BID Addendum-01

Project No.
JCDT23-0185

Title
Bid Clarification 01

Project Name
St Clair County Heath Dept Relocation

Drawing Title
PARTIAL FLOOR PLAN & PARTIAL REFLECTED CEILING PLAN - BASEMENT

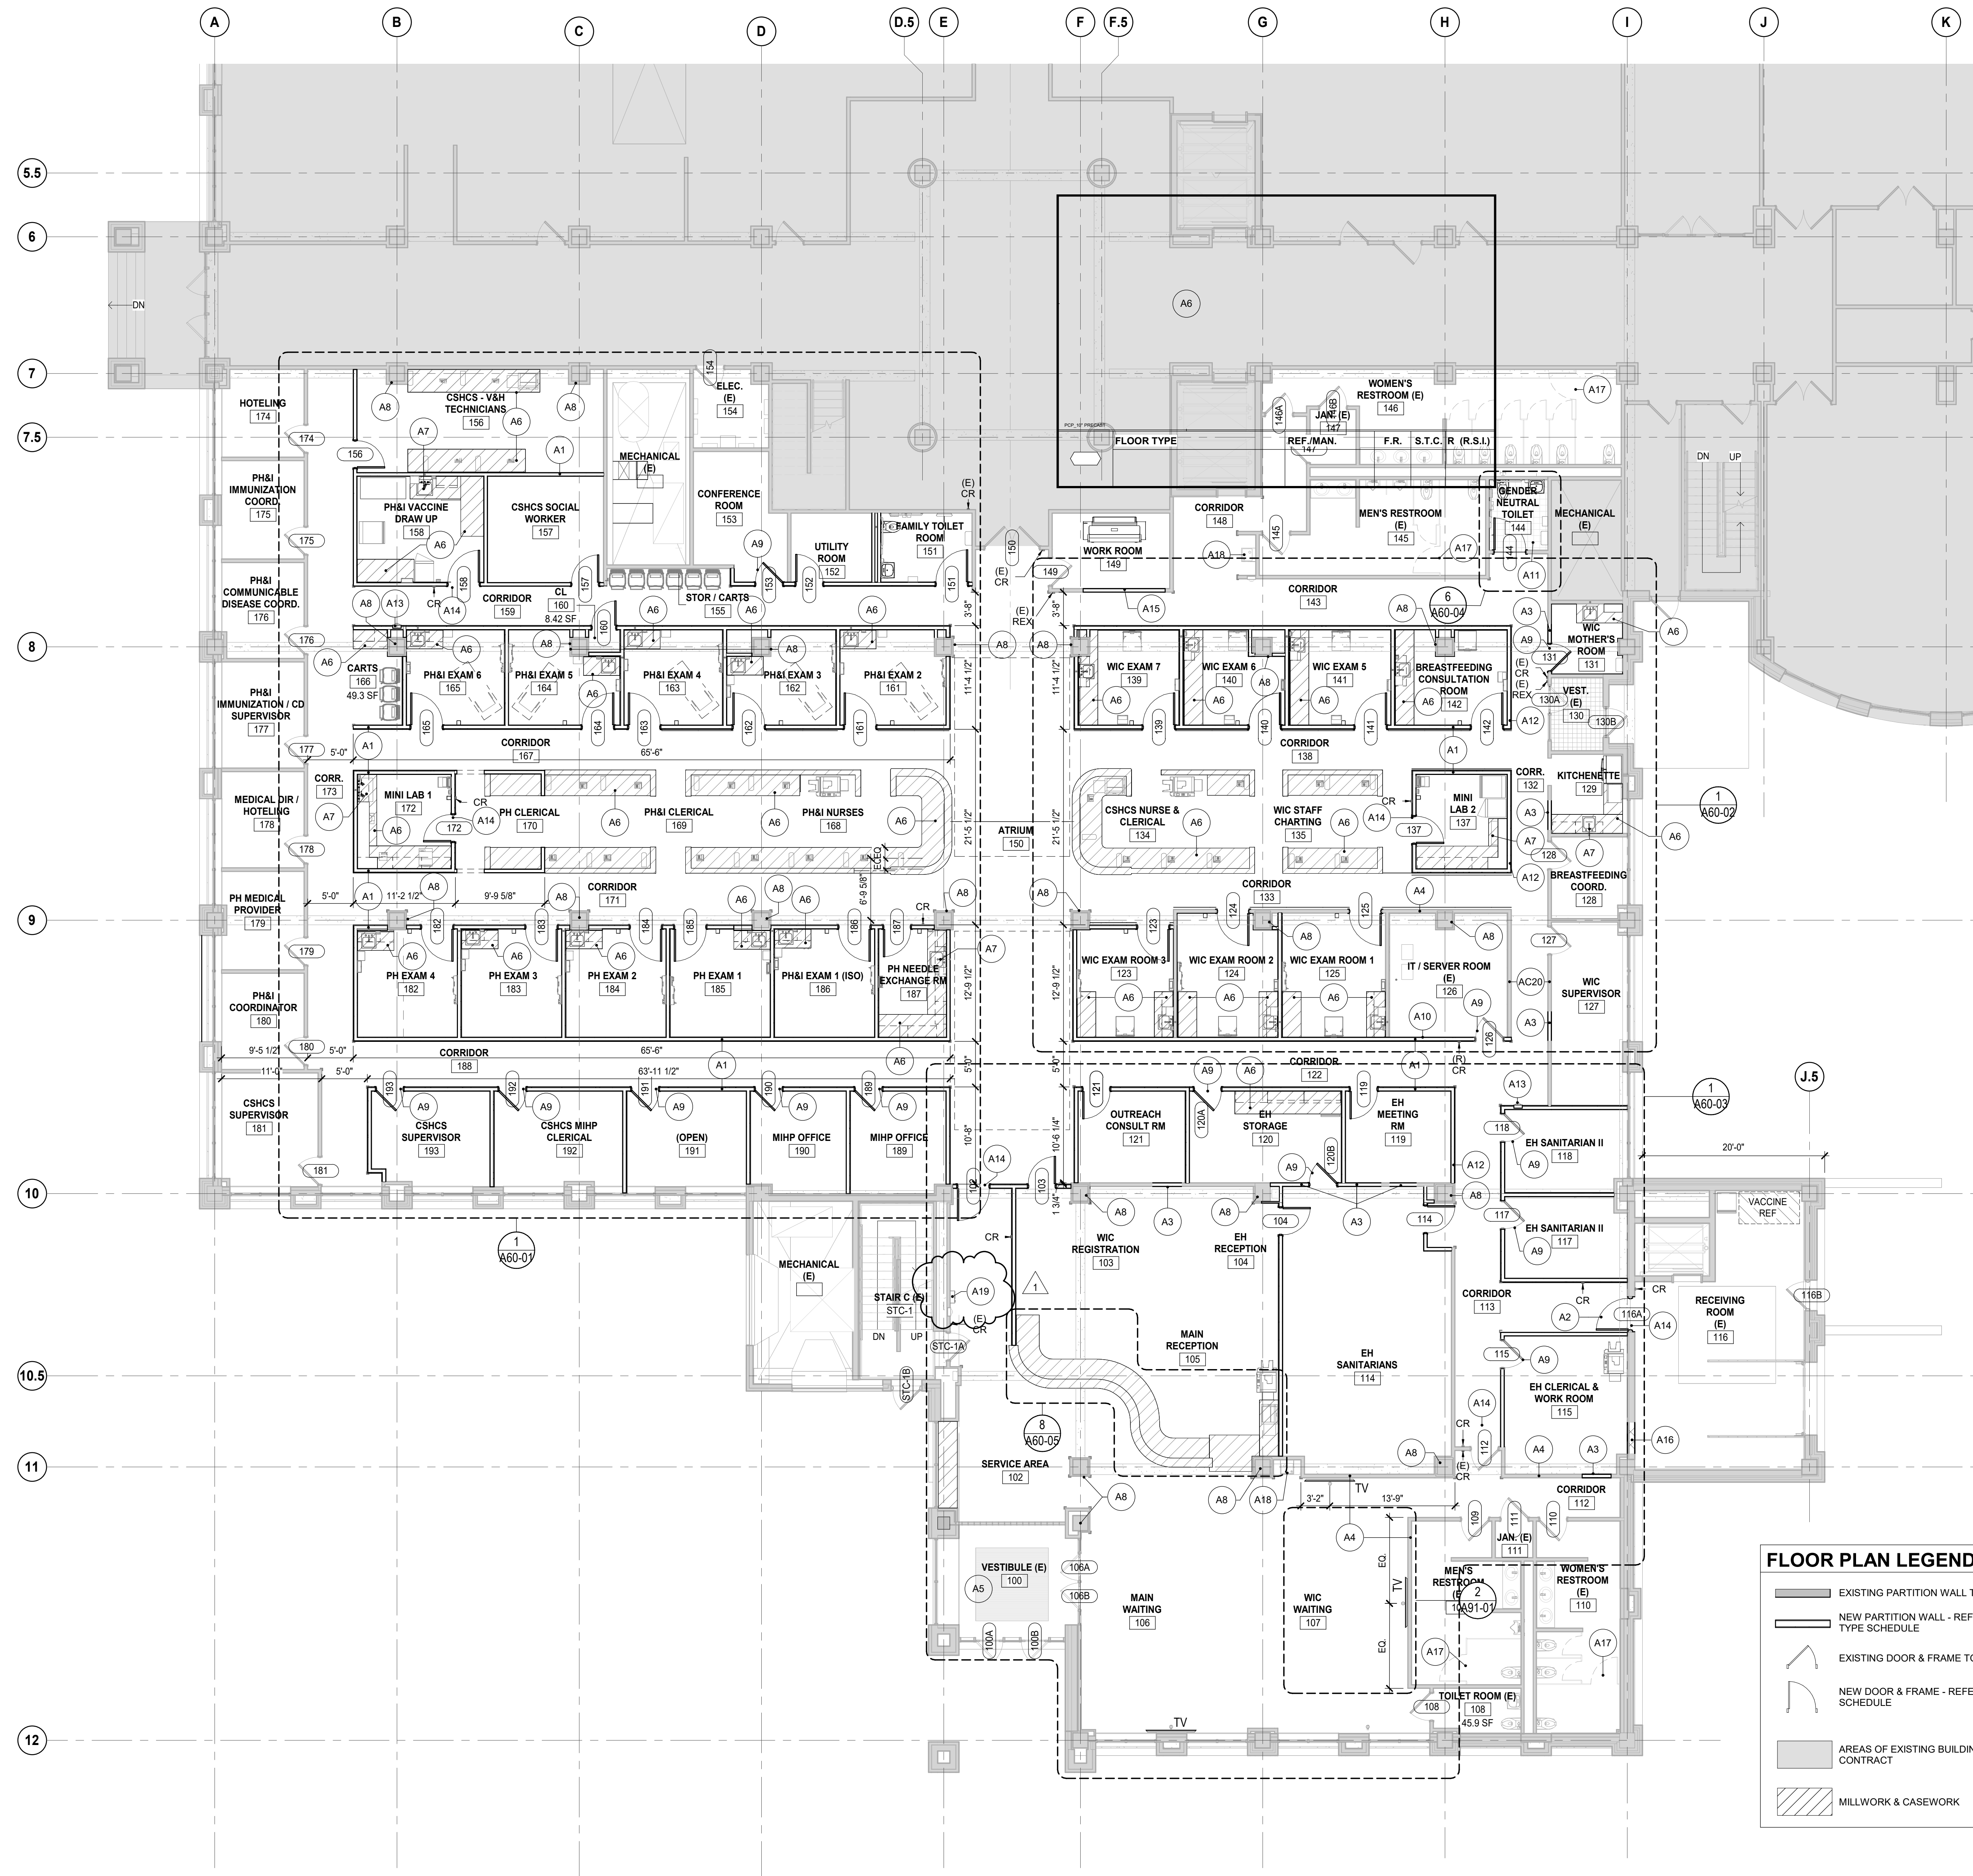
3. Sheet A20-00 – PARTIAL FLOOR PLAN & PARTIAL REFLECTED CEILING PLAN - BASEMENT
 - a. Added sheet to show new mechanical work in basement.
4. Sheet A02-01 – FLOOR PLAN – LEVEL 01

1 FINISH PLAN - LEVEL 01
 SCALE: 1/8" = 1'-0"

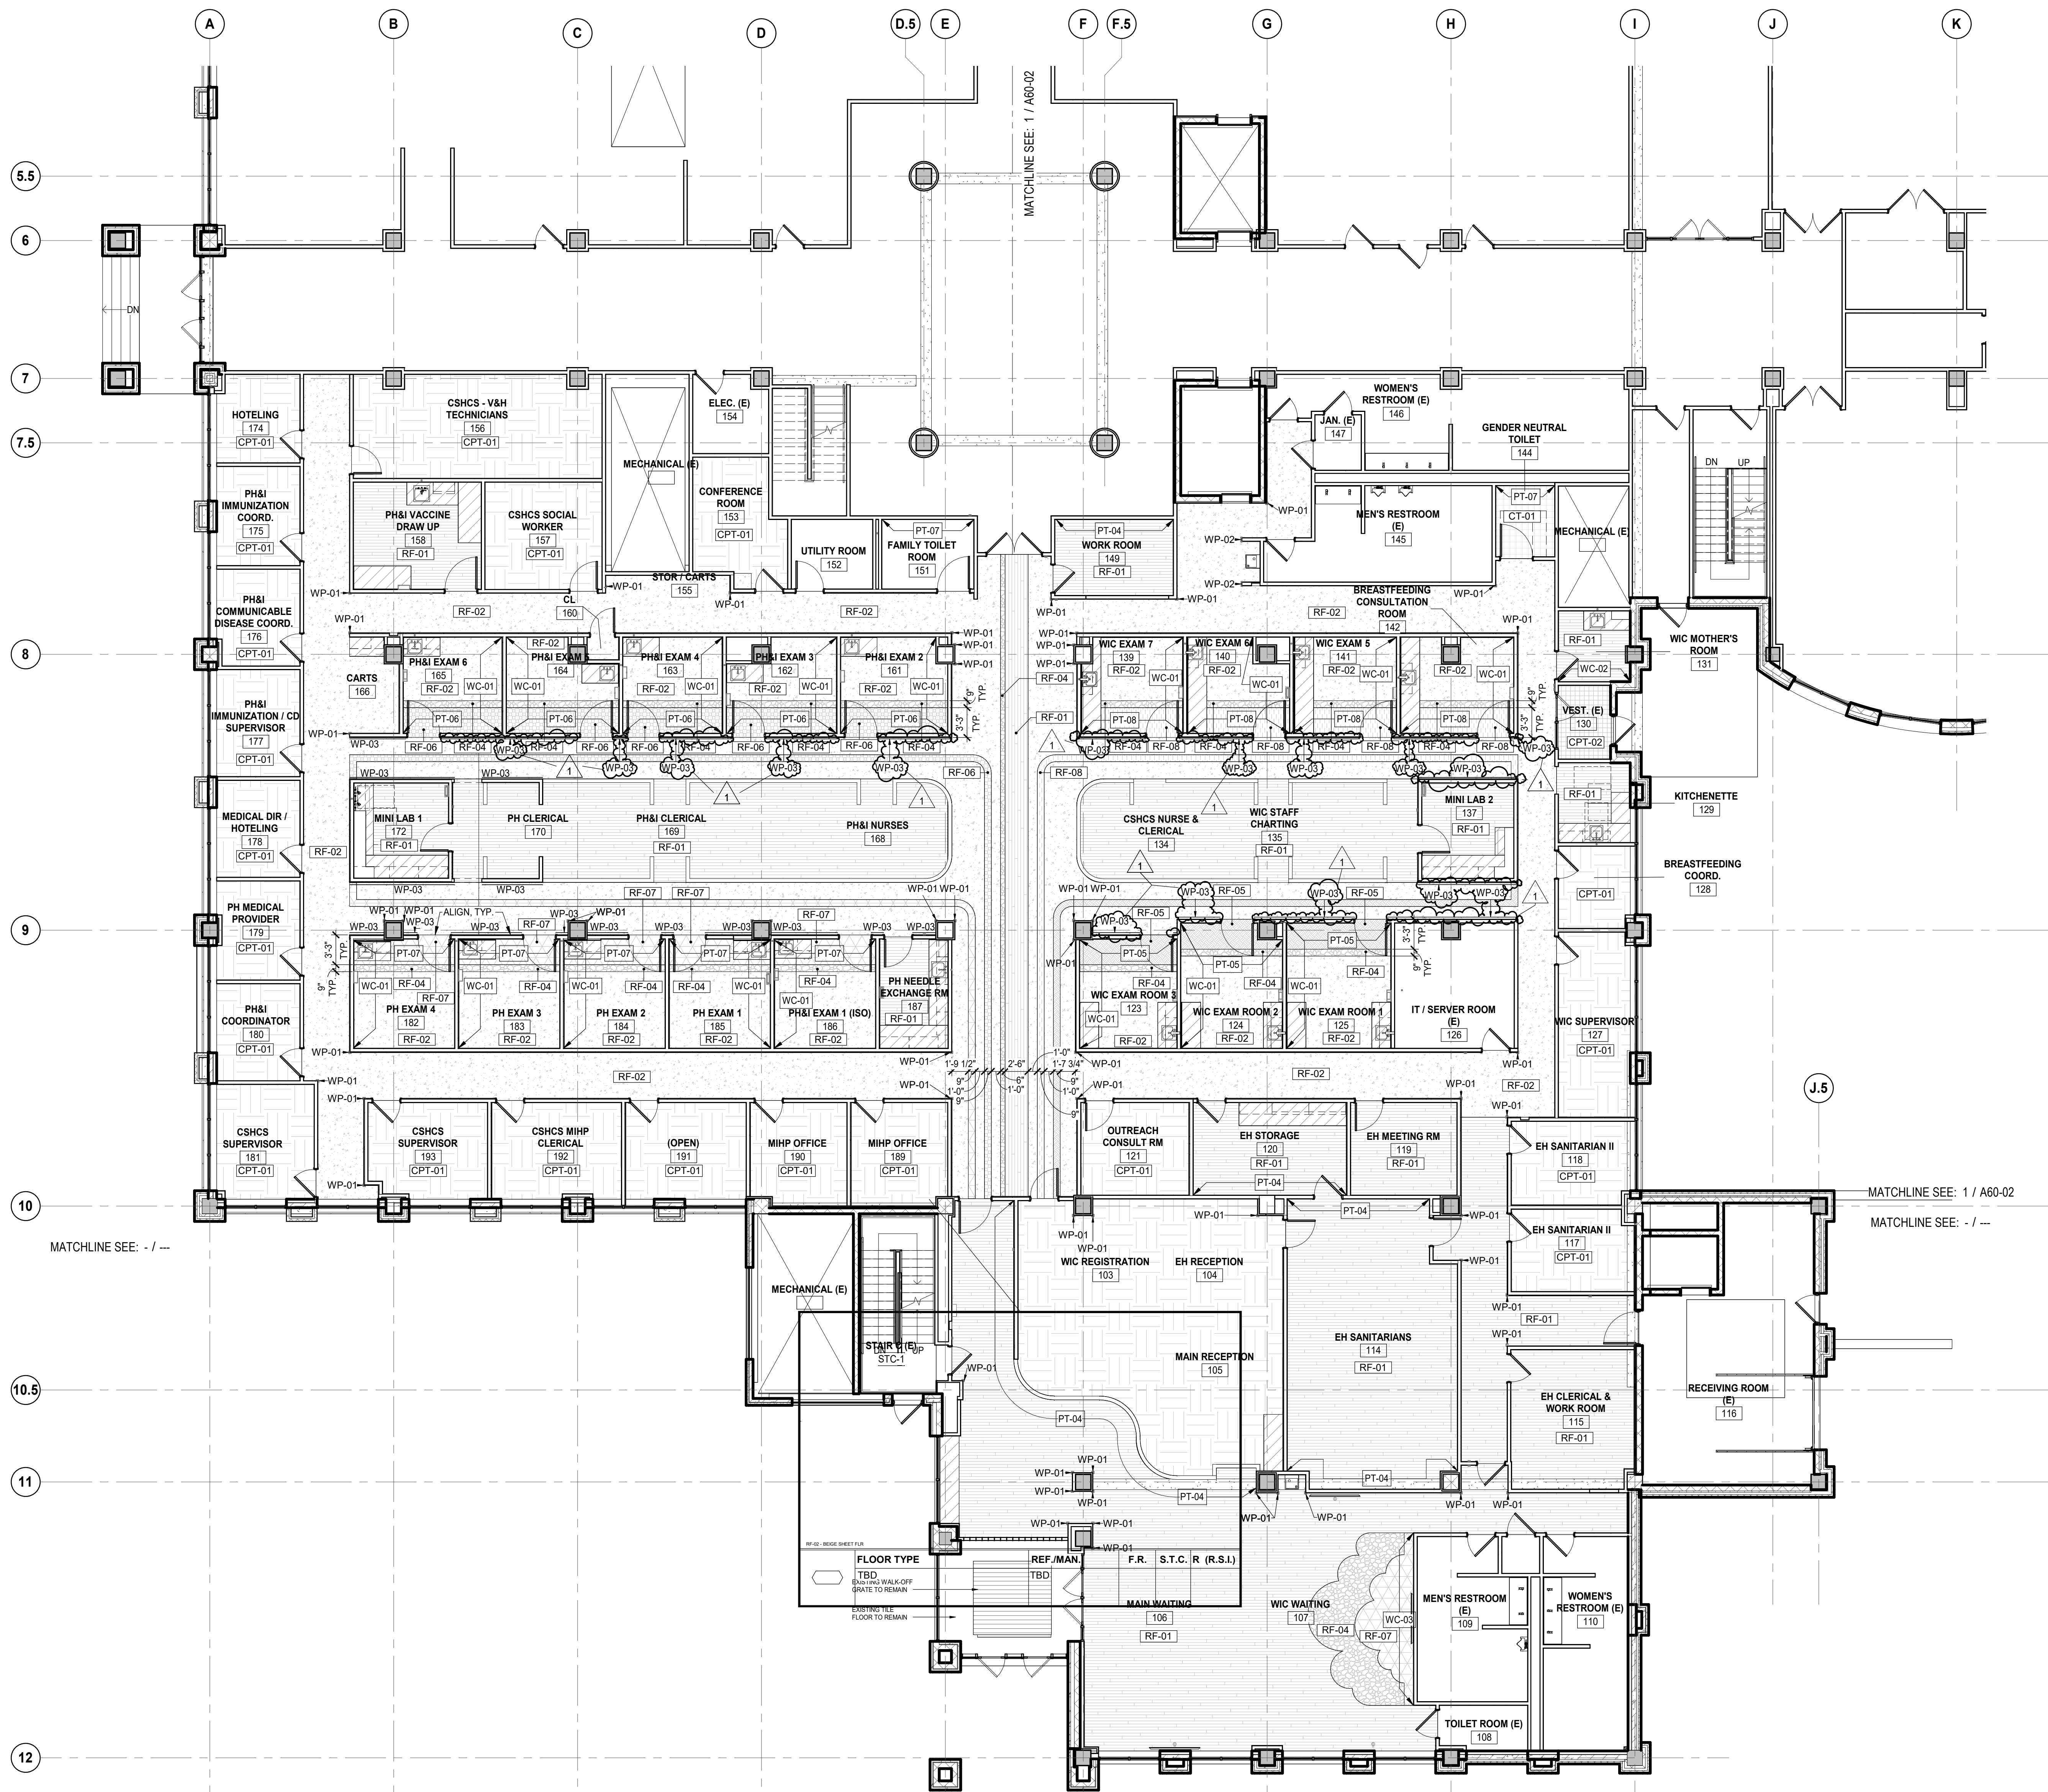
- b. Revised legend to include chair rail WP-04 as indicated.
 - c. Revised schedule to include description for WP-02 as indicated.
7. Sheet A91-01 – FINISH PLAN - LEVEL 01

- a. Added wall protection WP-03 at indicated locations.
 - b. Removed WP-01 at indicated locations where WP-03 has been added.
 - c. Revised legend to include chair rail WP-04 as indicated.
